LINOTYPE IMPROVEMENT SHEET

NO. 300

UNIVERSAL DISTRIBUTOR BOX BAR POINT

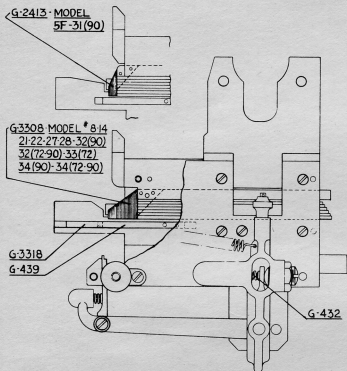
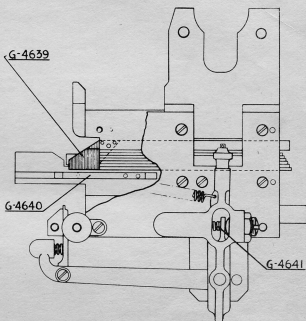
A universal Bar Point (G-4639) has been adopted for use with all Single Distributor Machines. This Long Bar Point was designed to accommodate all width Matrices. In conjunction with this improvement a lighter Cam Lever Spring (G-4641) is used to prevent bending or breaking of Bar Point, also a single Rail Spring (G-4640) is used in place of the current Springs (G-3318 & G-439) to prevent twisting of matrices in the Distributor Box when Distributor Shifter is withdrawn.

All new Model 5, 31, 32, 33, 34 Machines.

Can be applied to all outstanding Model 31, 32, 33, 34 having the Long Bar Point, by substituting parts indicated, for Model 5, 31(4)(90) having the short Bar Point, it is necessary to substitute the Distributor Box (Assembled).
